Part 15.247 Bluetooth**QUESTION 1.**

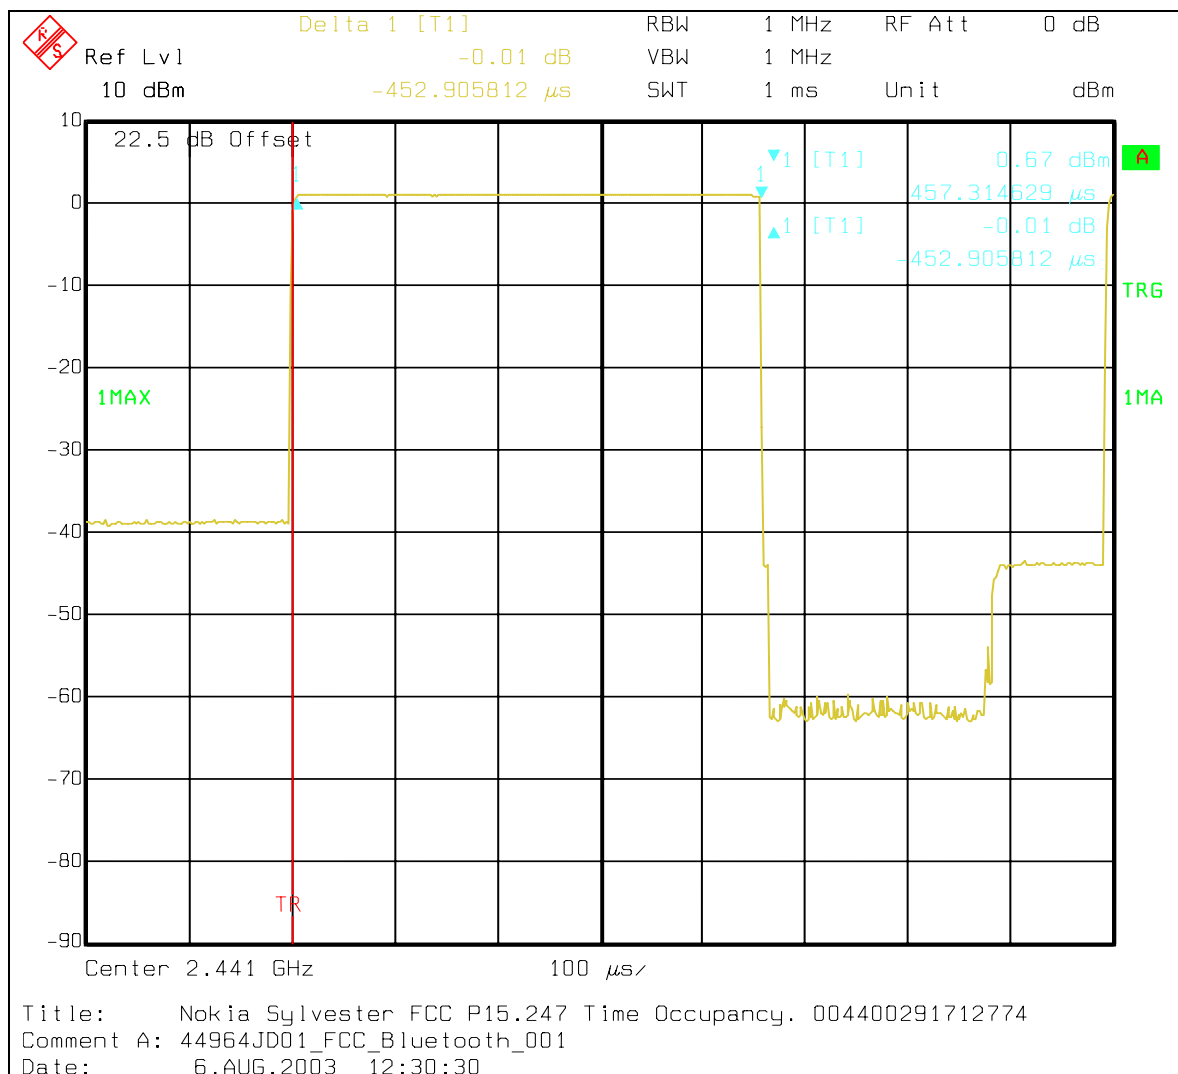
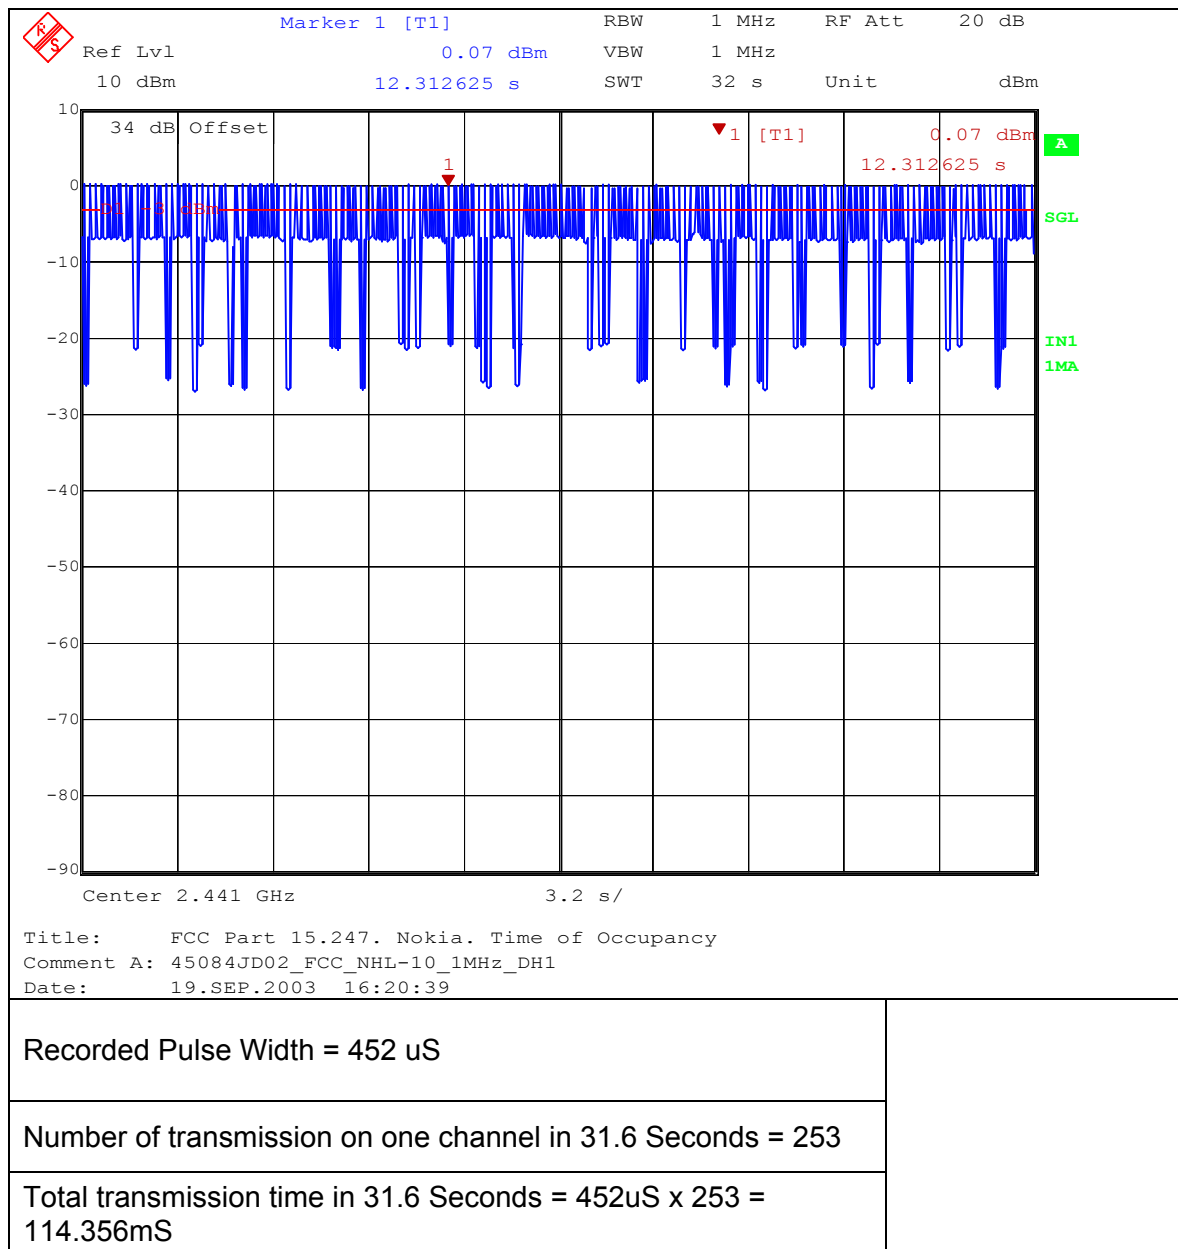
Please note that it appears that you have incorrectly measured channel occupancy. The plot reported shows a span of 83MHz including all channels and a sweep time of 20ms. Please note that this does not match your stated measurement procedure in section 9. The correct measurement is to be done with zero span centered on a single channel and a sweep time of 30 seconds, while the device is in hopping mode. This is to be repeated sufficient number of time to count the maximum occupancy per channel over the specified time limit. Please also note that the dwell (channel occupancy) data reported does not agree with normal and/or typical Bluetooth characteristics. Bluetooth devices typically have three modes of operation including data mode and inquiry mode. Because inquiry mode hops through significantly fewer total channels, inquiry mode may actually be worse case. Please re-measure your channel occupancy following the accepted FCC measurement procedure guideline for channel occupancy found in DA-000705. Please account for the possibility of other than data mode being worse case.

I can confirm that the data presented was incorrectly presented within the report.

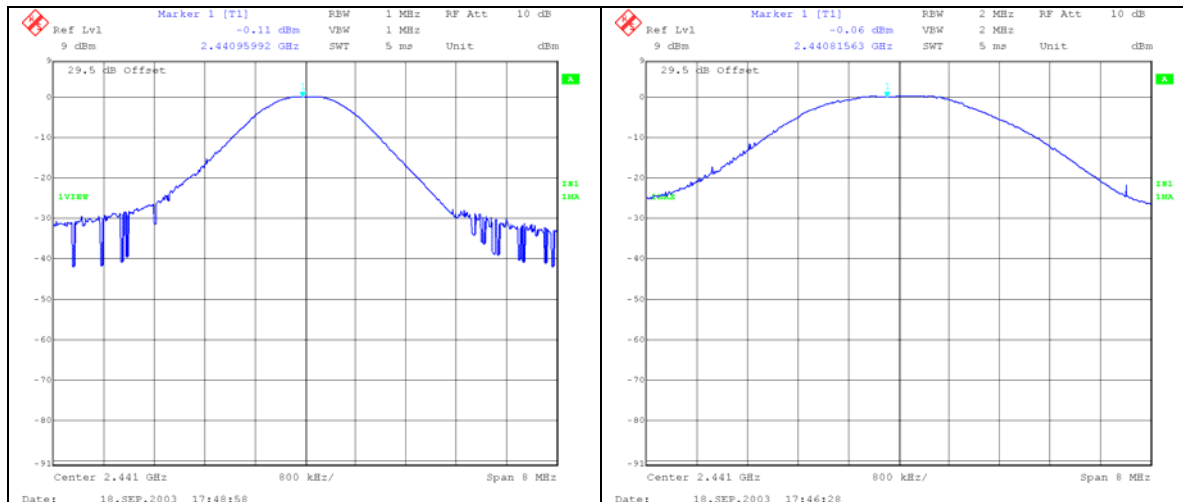
Please note that when using a resolution bandwidth narrower than the displayed device 6dB bandwidth for power measurements, a bandwidth correction factor may need to be employed to account for any error introduced in the measurement by this condition. The displayed device bandwidth shown in the plots show an approximate device 6dB bandwidth of about 1.5MHz and a resolution bandwidth of 1MHz. This means that a resolution bandwidth correction factor of $10\log(\text{displayed Bw}/\text{res bandwidth})$ or 1.75dB may have to be included. Please include this correction factor of alternately verify if this is not needed (e.g measuring the power using a res band width of 2MHz; or by conducted measurements using a power meter or diode detector).

It is not understood where the 6dB bandwidth comes from? The procedure outlined in DA00-705 for carrier output power requests that a resolution bandwidth greater than the emissions 20 dB bandwidth be used. 1 MHz is greater than the 20dB bandwidth.

The assumption is correct regarding the effect measurement bandwidths have on a wideband signal, which is why we chose a measurement bandwidth of 1MHz. Your TCB is referring to the wrong measurement bandwidth type. When referring to power bandwidths you refer to its 3dB bandwidth. This is at the point where half the signals power is observed. A Bluetooth device has a 3 dB bandwidth slightly less than 1MHz. This means using any 3 dB bandwidth equal to or greater than 1MHz will have no effect on the emissions amplitude. A 6dB bandwidth could possibly be used when measuring the bandwidth of a voltage based signal. This indicated bandwidth would then be at half the voltage points.

Please see following plots confirming this. There is about a 0.05dB difference. This difference is no as a function of emission bandwidth relative to measurement bandwidth. It is accounted for through measurement uncertainty.
